## **Executive Director's Recommendation**

Commission Meeting: January 9, 2020

<b>PROJECT</b> <b>National Desert Storm and Desert Shield Memorial</b> National Mall Southwest Corner of 23rd Street and Constitution Avenue, NW Washington, DC	<b>NCPC FILE NUMBER</b> 7745
<b>SUBMITTED BY</b> United States Department of the Interior National Park Service	<b>NCPC MAP FILE NUMBER</b> 1.44(73.10)45053
<b>REVIEW AUTHORITY</b> Commemorative Works per 40 U.S.C. § 8905	<b>APPLICANT'S REQUEST</b> Approval of comments on concept plans
	<b>PROPOSED ACTION</b> Approve comments on concept plans
	<b>ACTION ITEM TYPE</b> Staff Presentation

## Existing Flood Elevations

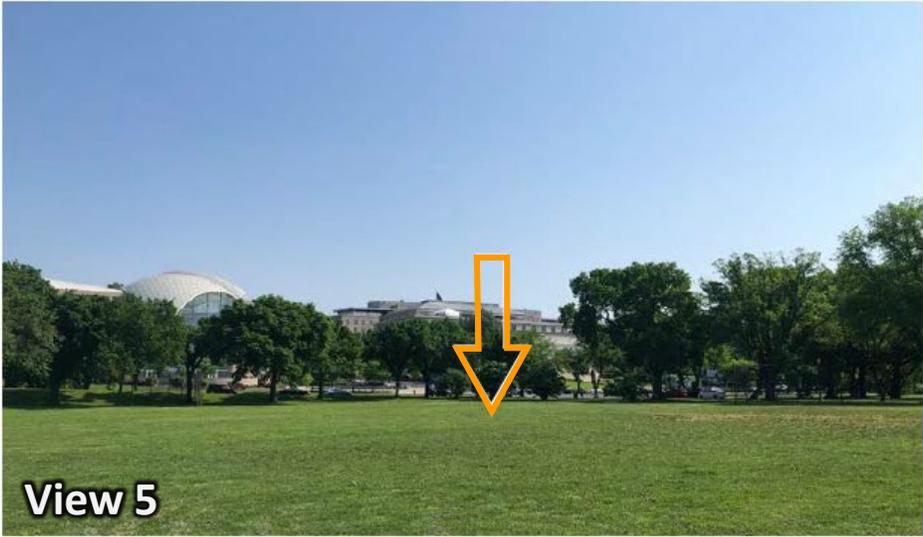
**Notes** the siting and design of the proposed memorial are intended to have minimal impacts on these future infrastructure projects.

# Storm

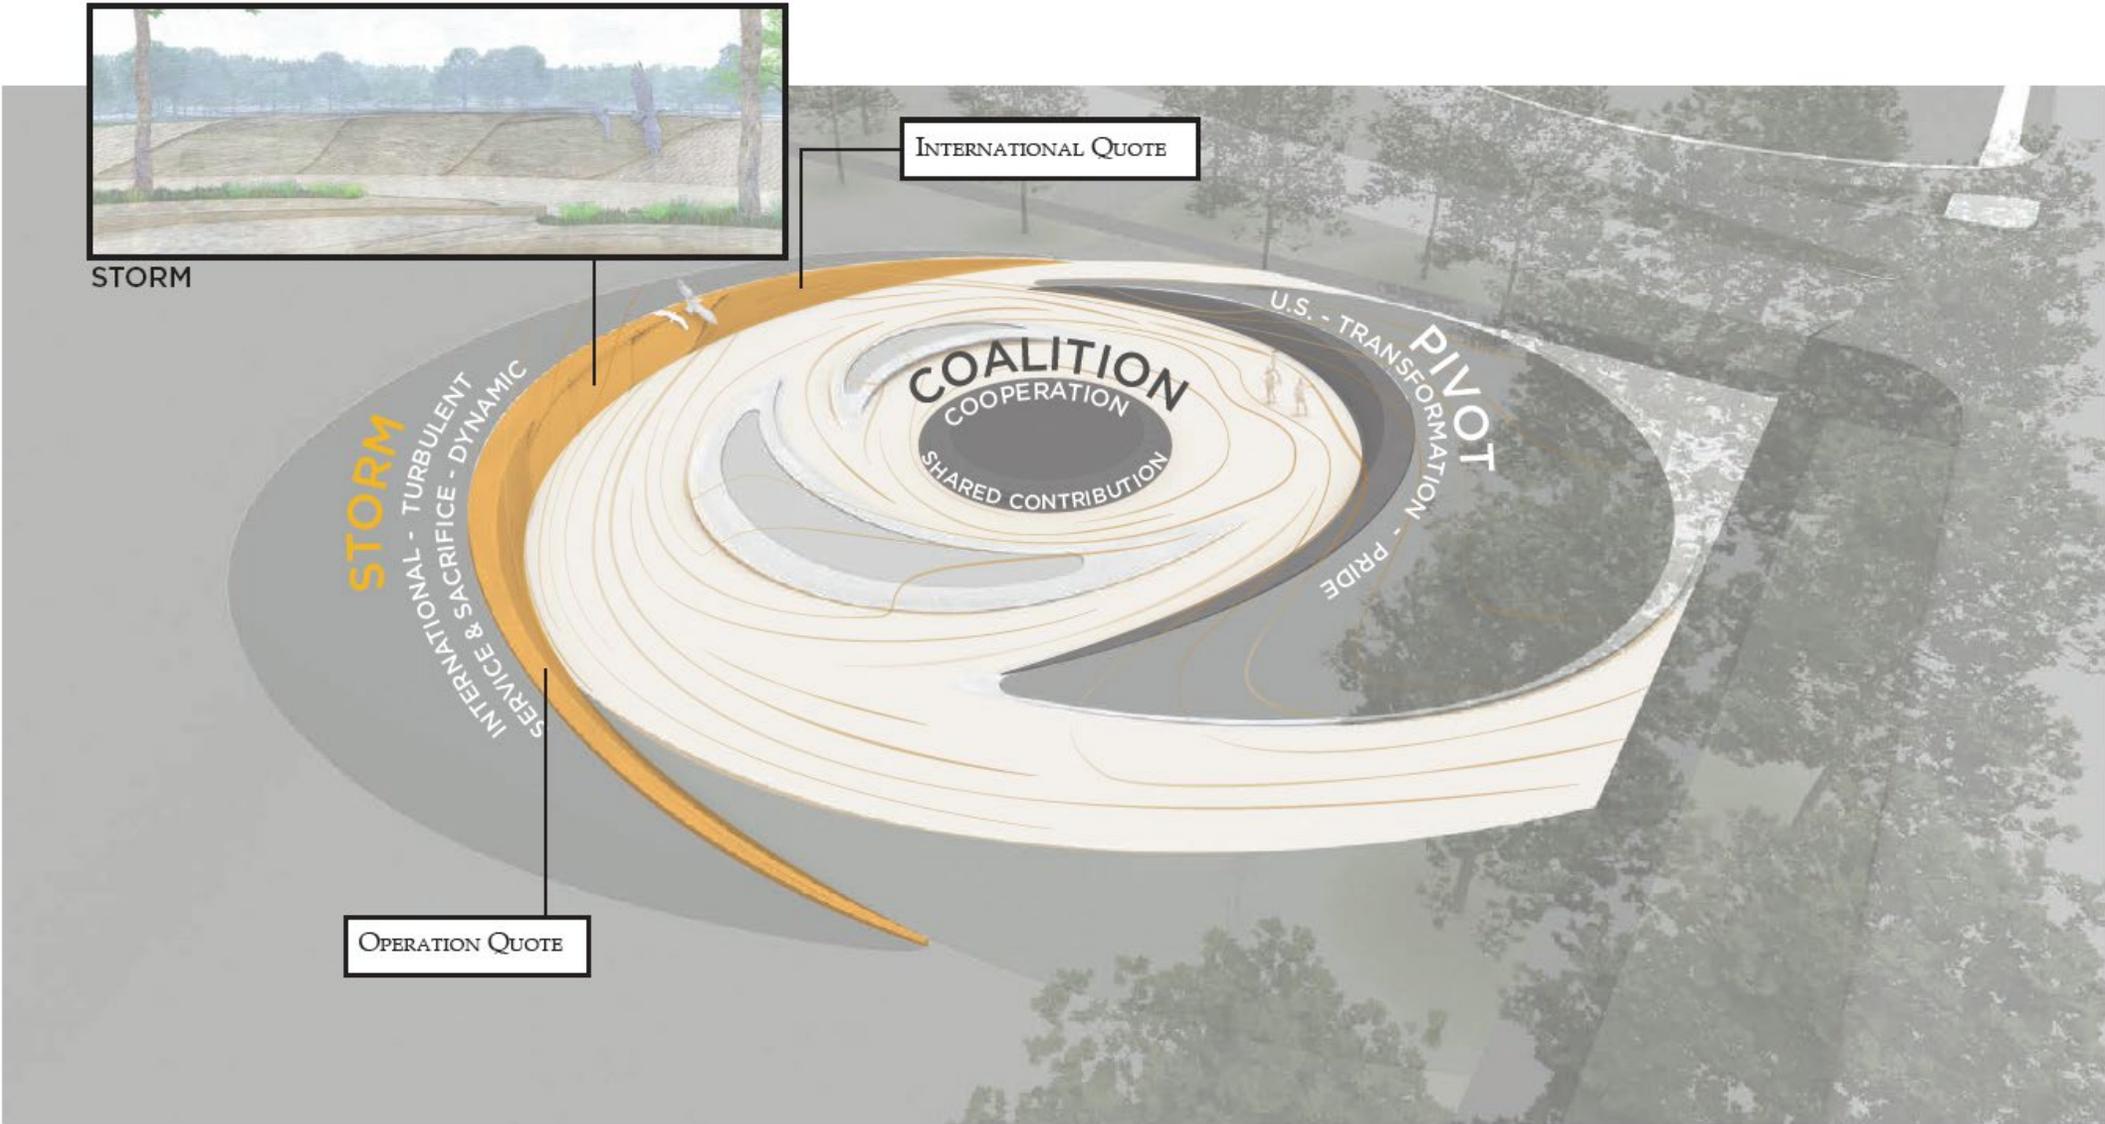
**Recommends** the proposed cast sculpture of the falcon and eagle symbolizing liberation and leadership relate to the imagery proposed on the “storm” wall.

**Finds** the proposed quotations support the “storm” and “pivot” themes; however, the overall physical expression of the commemorative themes can be strengthened through further design of the stone carvings and bas-relief imagery.

# Pivot

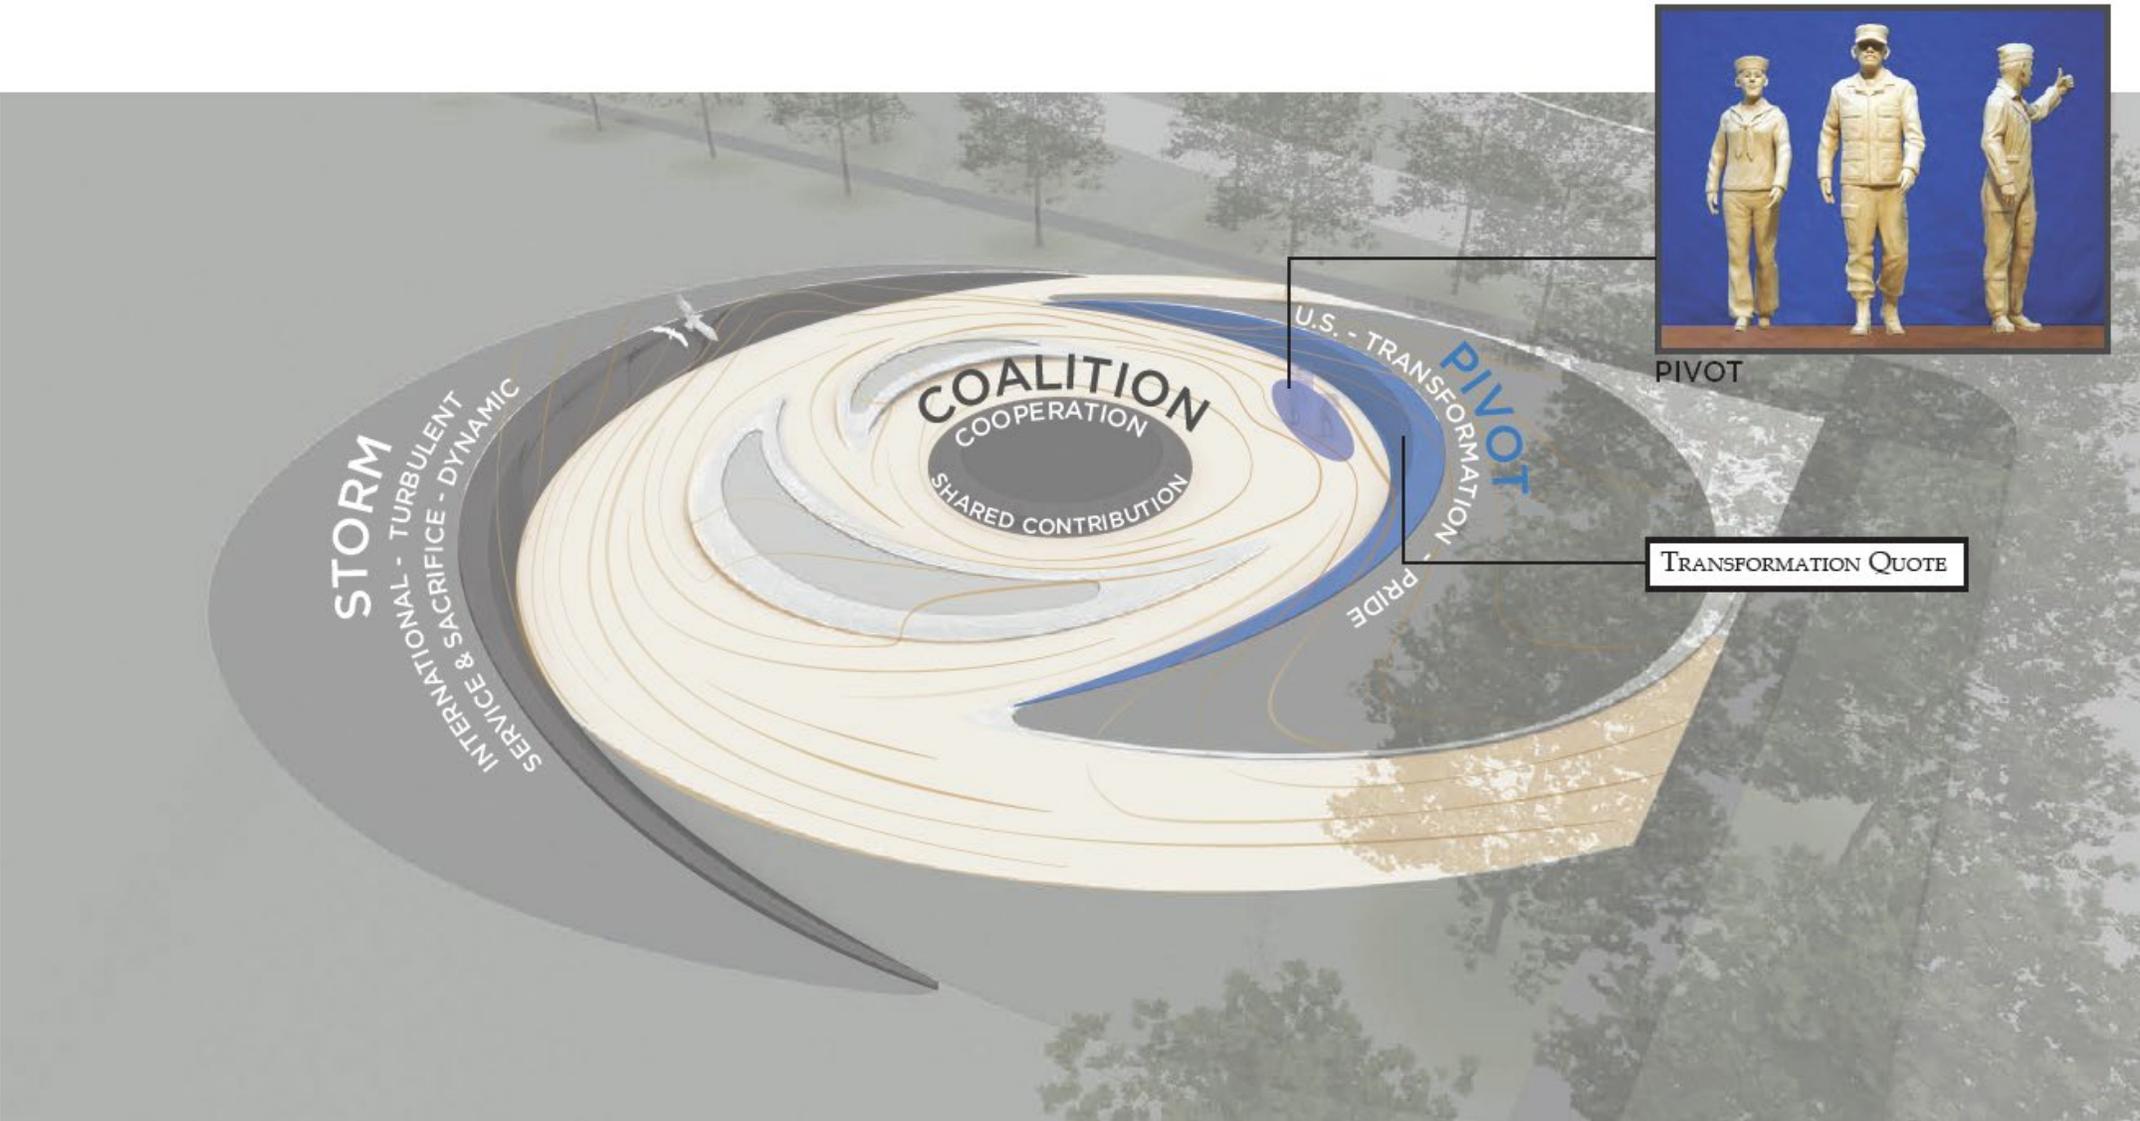
**Finds** the scale, orientation and placement of the statues appearing above the berm creates an unwelcoming approach from the corner of 23<sup>rd</sup> Street, NW and Constitution Avenue.

**Notes** the literal depiction of the service members conflicts with the abstract design of the landscape-oriented memorial.

**Requests** the applicant consider alternatives to the statues that express the “pivot” theme and complement the landscape character of the memorial in the next submission.

# Coalition

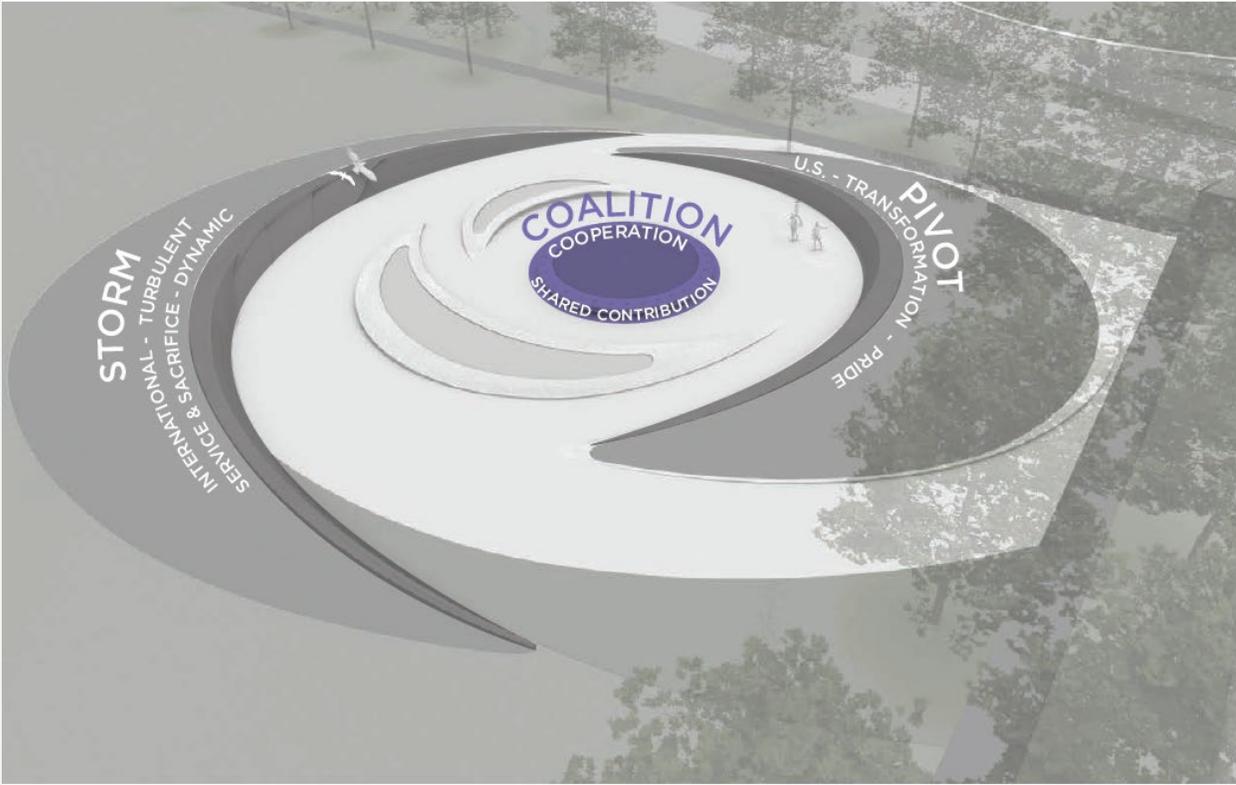
**Finds** the coalition theme is successfully expressed through the circular form of the central element and the recognition of the multiple nations involved in the War around the circumference.

**Requests** the applicant provide alternatives for the surface treatment of the central element as seen when the water feature is turned off, noting that the treatment should contribute to the overall narrative.

# Impacts: Trees

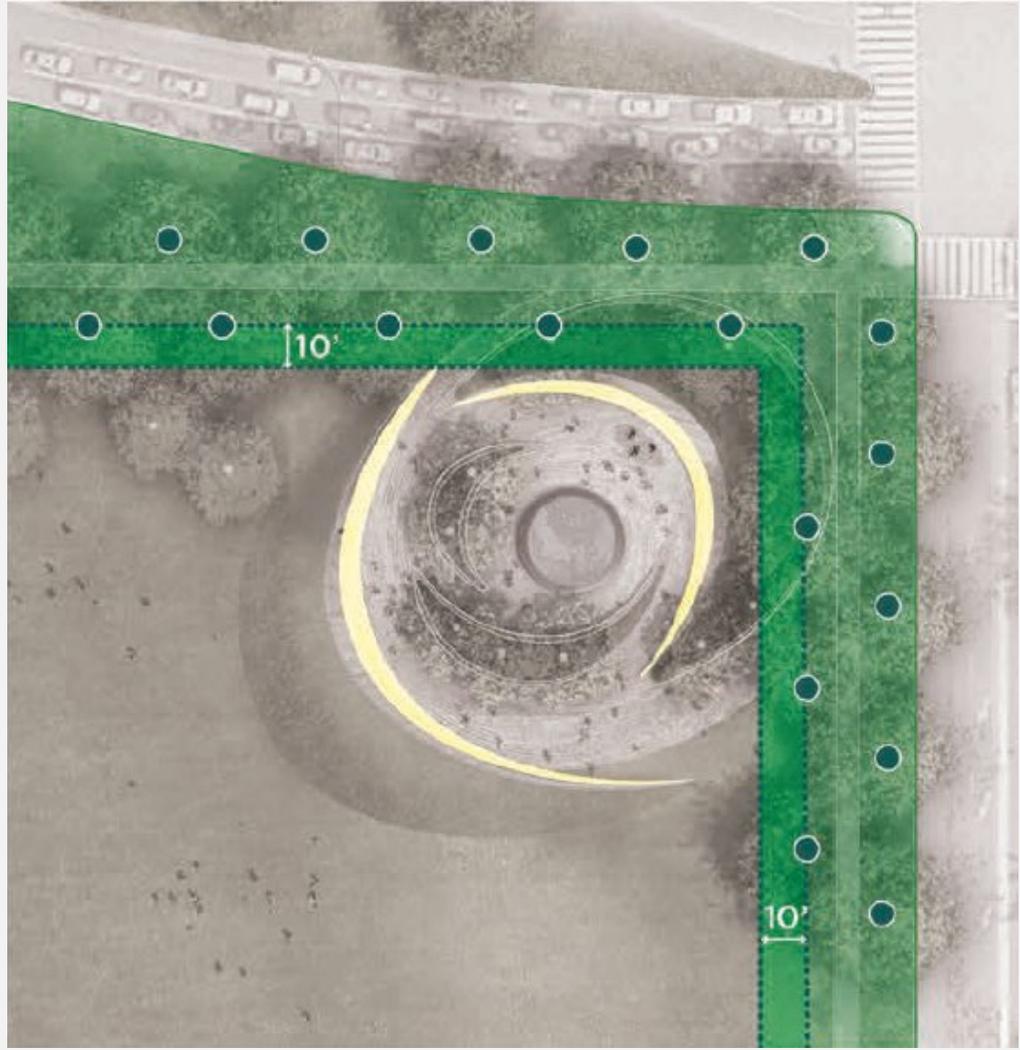
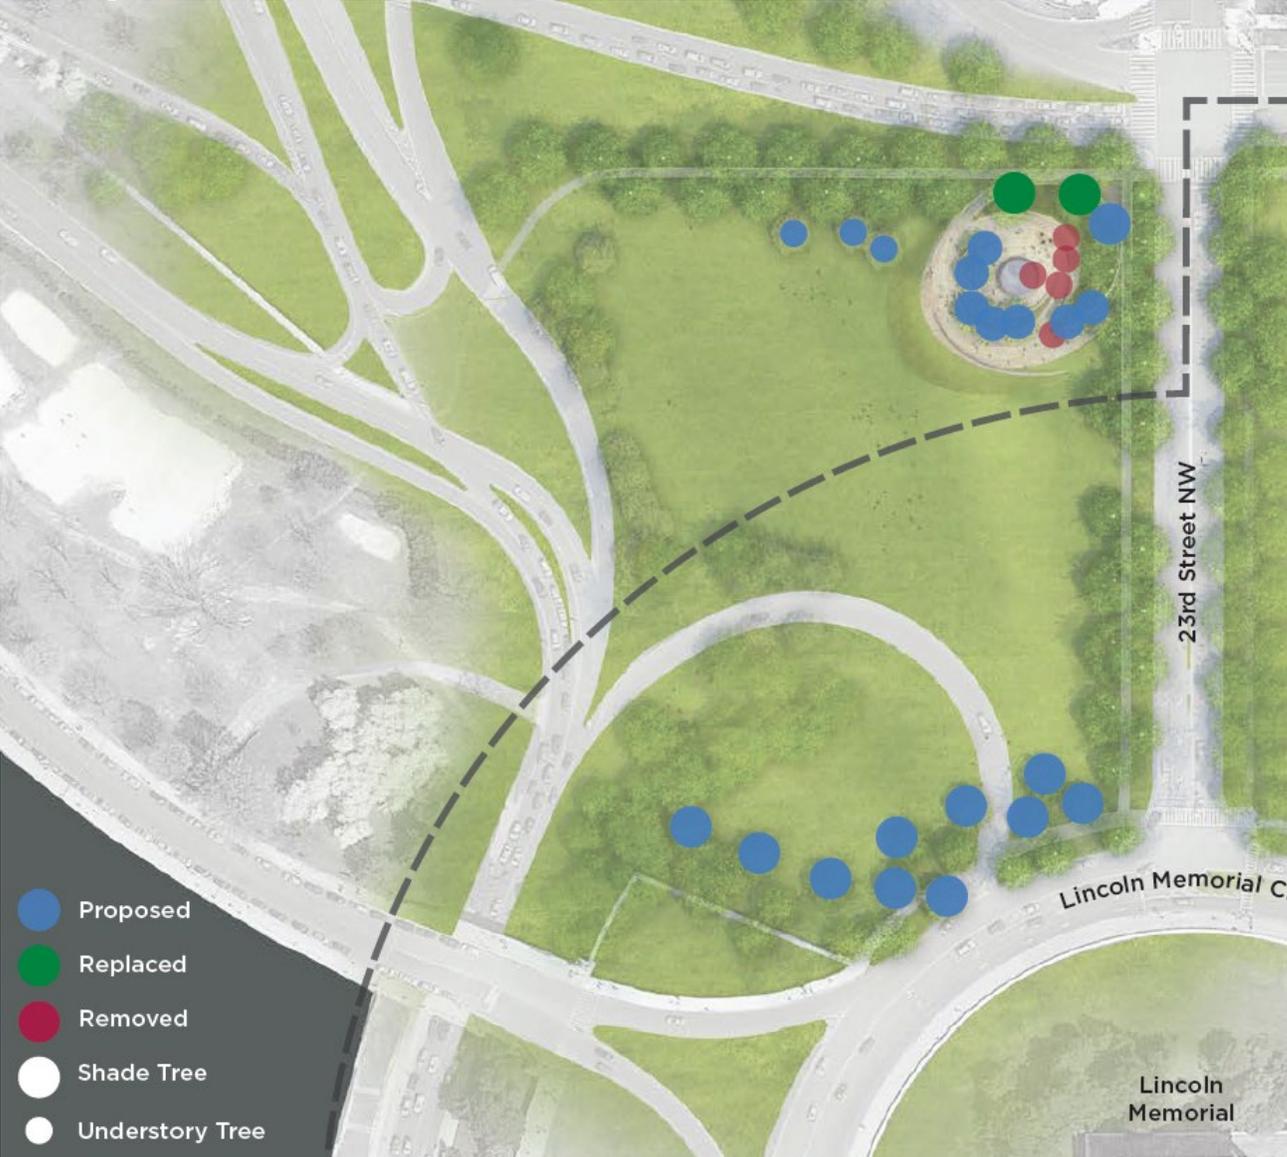
**Notes** the applicant has made a conscious effort to minimize tree loss and proposes new trees to maintain the allee of trees on 23<sup>rd</sup> Street, NW and Constitution Avenue and maintain consistency with the Lincoln Memorial Cultural Landscape.

**Recommends** the applicant consult with a certified arborist to evaluate impacts to existing trees based on the proposed grading and conceptual design and to ensure proper tree protection measures are in place.
